CERTIFICATE OF APPROPRIATENESS

Property: 7723 Glenheath Drive, Lot 14, Block 64, Glenbrook Valley Subdivision. The property includes a historic 2,274 square foot residence situated on a 7,685 square foot interior lot.

Proposal: Alteration – Replace four original windows on the front elevation with new vinyl windows. The existing windows are damaged and inoperable.

INVENTORY PHOTO

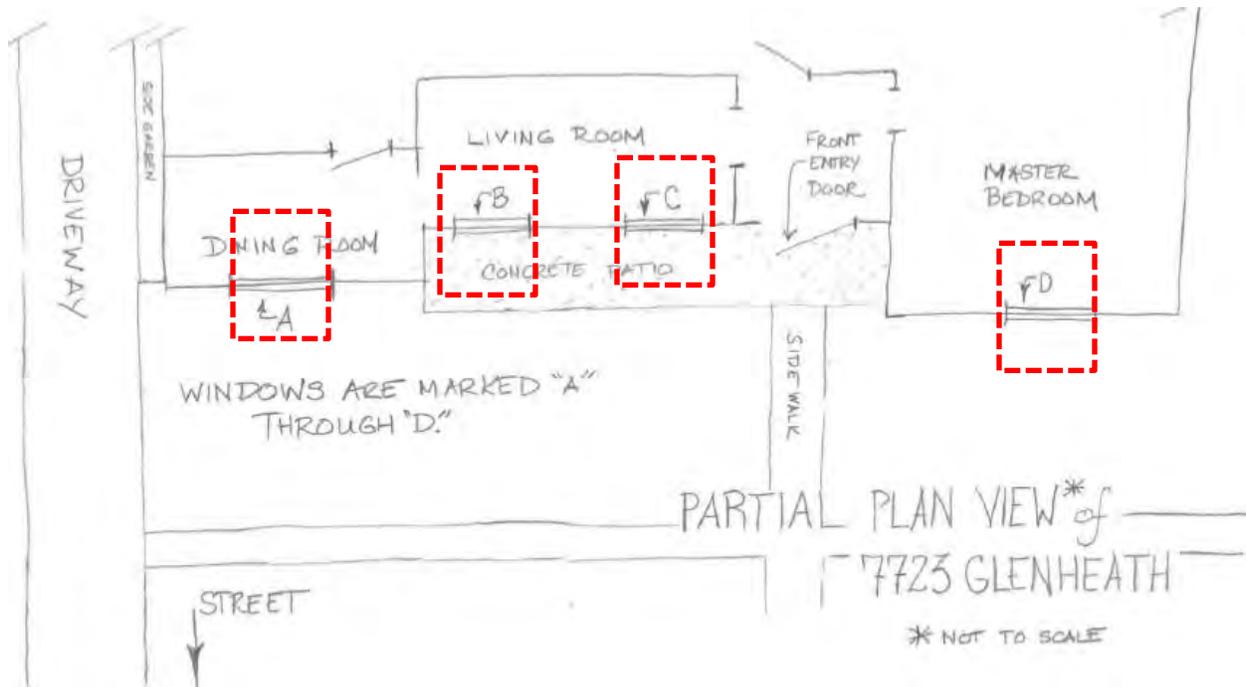
- Staff confirmed that existing windows are damaged beyond reasonable repair during a site visit.
- Proposed windows will match the existing window openings.

EXISTING DAMAGE: WINDOW A

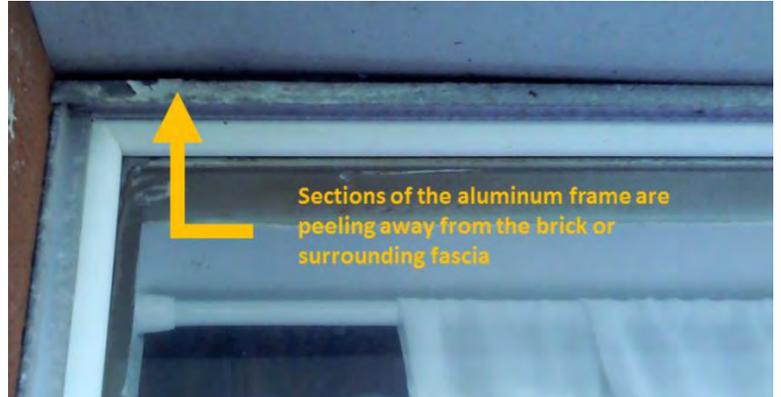
Dry Rot on Gaskets

Broken Retention Spring

Window A – features two broken retention springs, dry rot damage in the plastic gasket material, and a bent frame.
